IMPORTANT SAFETY RECALL

Airstream 19 Ft. Travel Trailer Inverter Recall

NHTSA Recall Number - 19V-655/Transport Canada recall 2019-465

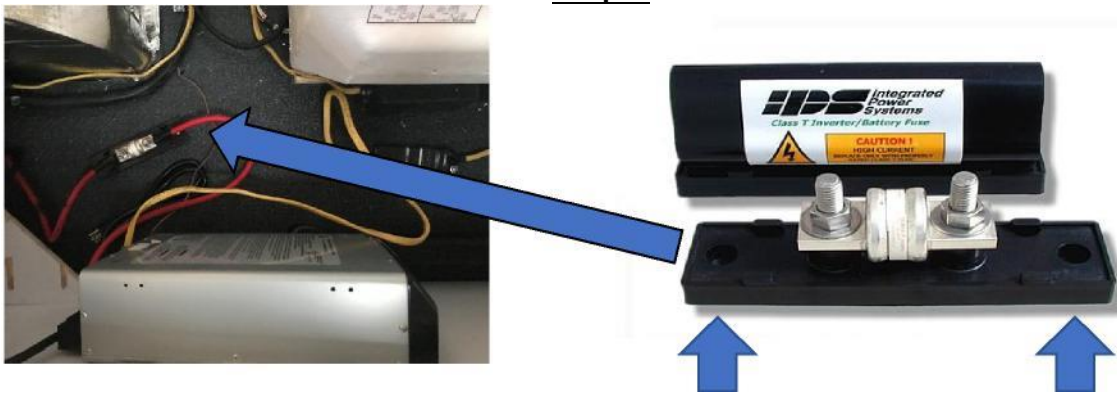
This is incorrect the inverter is on the panel and fuse holder is on the floor.

This is correct, the inverter is installed on the floor and the fuse holder is installed on the floor and has the plastic cover installed.

This is correct, the inverter is installed on the panel and the fuse holder is installed on the panel and has the plastic cover installed.

If both components are mounted on either the floor or the lower bed frame and the plastic protective fuse cover is installed then no other steps are needed. If they are not mounted correctly go to step two.

Relocate the fuse holder to the panel next to the inverter and attach it with 1/2" screws or if there is room on the floor area the inverter could be removed from the vertical panel and mounted directly to the floor.

If you loosened the nuts for the wires they will need to be retightened at a torque rating of 12.5 ft. lbs. The cover (part number 511969-100) snaps in the holder by squeezing the cover and placing it in the four notches.
